MIL-C-25955(USAF)

AMENDMENT 3

MILITARY SPECIFICATION  
CONNECTORS, ELECTRICAL, ENVIRONMENT RESISTING  
MINIATURE, WITH SNAP-IN CONTACTS

This amendment forms a part of Military Specification MIL-C-25955(USAF) dated 9 January 1958.

Figure 1 CONTACTS

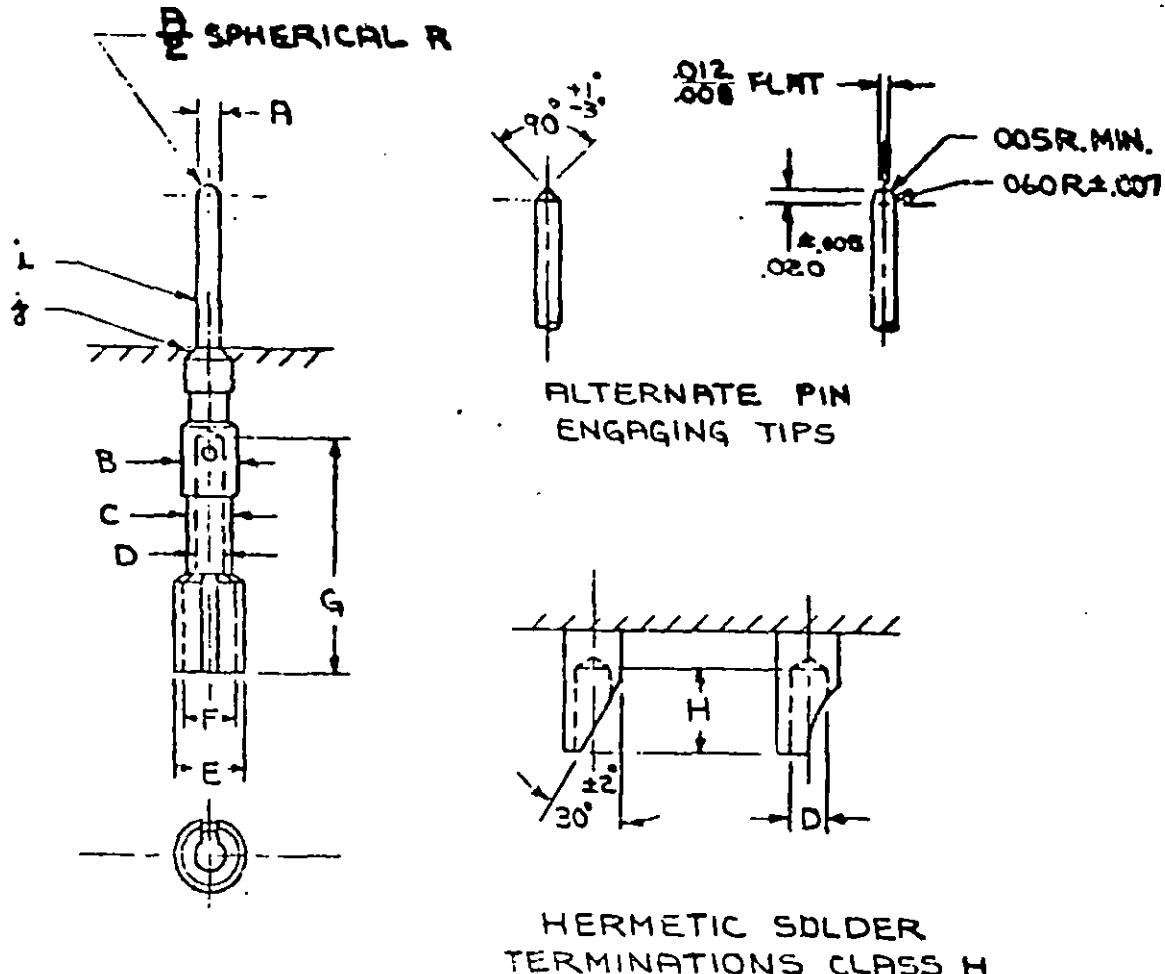
Page 6, figure 1: Delete and substitute the attached figure 1 which forms page 2 of this amendment.
